SERVICE BULLETIN

AUGUST 1995

GO-KART DEFLECTOR UPDATE

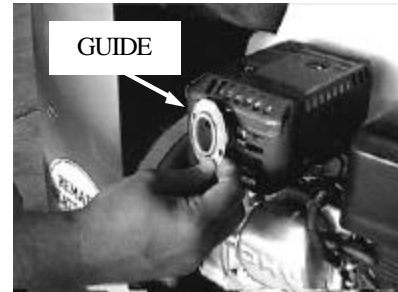
Excessive heat between muffler and protective shield causing fuel tank to get soft and may rupture.

Missing Guide.

Install Guide as seen in picture.

Guide, Muffler **Part#34407320**
